Detailed Site Plan
Departure from Design Standards
Departure from Parking and Loading Spaces
Seabrook – Parcel F

DSP-20010
DDS-668
DPLS-479

STAFF REPORT

SUBJECT: Detailed Site Plan DSP-20010
 Departure from Design Standards DDS-668
 Departure from Parking and Loading Spaces DPLS-479
 Seabrook – Parcel F

Figure 1: Site Plan

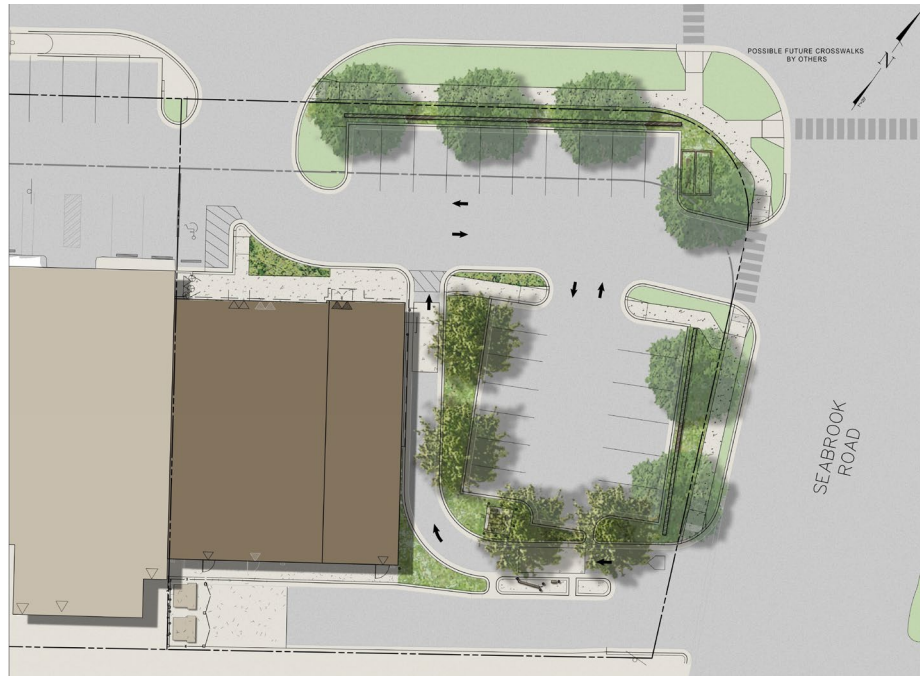
6. **Design Features:** The subject DSP proposes construction of 3,350 square feet of commercial retail space, for which a tenant has not been determined, and a 1,600-square-foot eating and drinking establishment with a drive-through, specifically a Dunkin Donuts. One building is proposed, which is connected to the existing commercial strip on the adjacent Parcel D, with parking provided to the north and east. The site is accessed from Seabrook Road on the east, Lanham Severn Road on the north, and an inter-parcel connection to Parcel D on the west. The DSP proposes a one-way drive-through on the east side of the building, and a loading space/trash dumpster area with access driveway to the south of the building. Sidewalks are proposed, allowing pedestrian access from Lanham Severn Road and Seabrook Road into the site. However, crosswalks are not included at all vehicular crossings for safe passage and are recommended to be provided, as conditioned herein.

Loading is required for the eating and drinking establishment proposed in combination with the commercial retail and is located at the rear of the building, between it and the adjacent railroad tracks. However, access to this facility is proposed by a drive aisle that does not meet the minimum width and requires a DDS. The applicant has filed DDS-668, which requests a reduction in the required standard 22-foot-wide driveway access to 16 feet. Staff recommends approval of the DDS, as discussed in Finding 7. The dumpster is adequately screened by the building and a six-foot-high enclosure.

- a. Provide the correct plat reference in the property information section of the cover sheet.
 - b. Provide a continental crosswalk on the drive aisle at the point of vehicle entry along Lanham Severn Road, unless modified by the Maryland State Highway Administration, with written correspondence.

- d. Provide a continental crosswalk on the drive aisle at the front and rear points of vehicle entry along Seabrook Road, unless modified by the Prince George's County Department of Permitting, Inspections and Enforcement, with written correspondence.

- e. Provide a six-foot-wide sidewalk and perpendicular, Americans with Disabilities Act accessible ramp connecting to Seabrook Road, unless modified by the Prince George's County Department of Permitting, Inspections and Enforcement, with written correspondence.

- f. Provide a six-foot wide sidewalk and perpendicular, Americans with Disabilities Act accessible ramp connecting to Lanham Severn Road, unless modified by the Maryland State Highway Administration, with written correspondence.

- g. Remove "Ramp and" from the notation on plans which reads "Future Ramp and Crosswalk (By Others)."

- h. Provide a minimum six-foot-wide sidewalk along the subject site's frontage of Seabrook Road, consistent with the 2017 *Department of Public Works and Transportation Urban Street Design Standards*, unless modified by the Prince George's County Department of Permitting, Inspections and Enforcement, with written correspondence.
- i. Provide a minimum six-foot-wide sidewalk along the subject site's frontage of Lanham Severn Road, consistent with guidance from the 2020 Maryland State Highway Administration (SHA) *Context Driven Access and Mobility for All Users*, unless modified by SHA, with written correspondence.
- j. Provide additional horizontal or vertical architectural elements on the building façade facing Lanham Severn Road, such as a masonry water table.
- k. Add the following note:
